Westinghouse Electric Company LLC  
Hematite Decommissioning Project  
3300 State Road P  
Festus, MO 63028  
USA

Subject: Partial Responses to Requests for Additional Information on Decommissioning  
Plan Chapters 1, 4, 6 and 7 (License No. SNM-00033, Docket No. 070-00036)

### **Partial Responses to Decommissioning Plan Requests for Additional Information on Chapters 1, 4, 6 and 7**

**Appendix A  
 Radiological Survey Report (Map)**

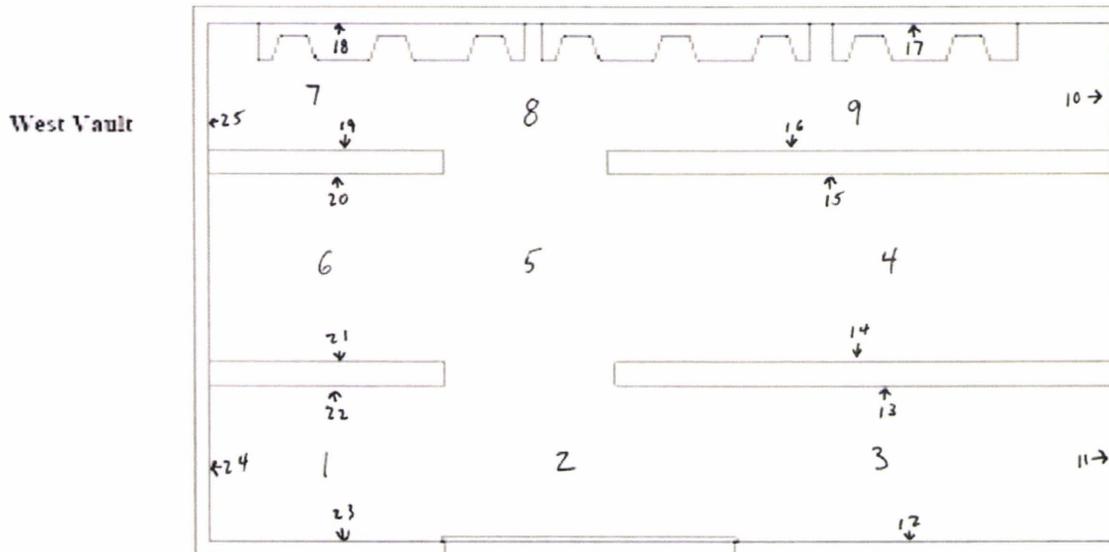
- A scale drawing or map of the rooms or work areas showing the locations of radionuclide material contamination.

- A scale drawing or map of the rooms or work areas showing the locations of radionuclide material contamination.

The most recent radiological surveys of Building 235 are attached below.

**Remarks:** The floor has thick yellow & magenta paint & is marked fixed contamination area. The cinderblock walls have a thin coat of green paint on them. Survey location corresponds to the number on the map.
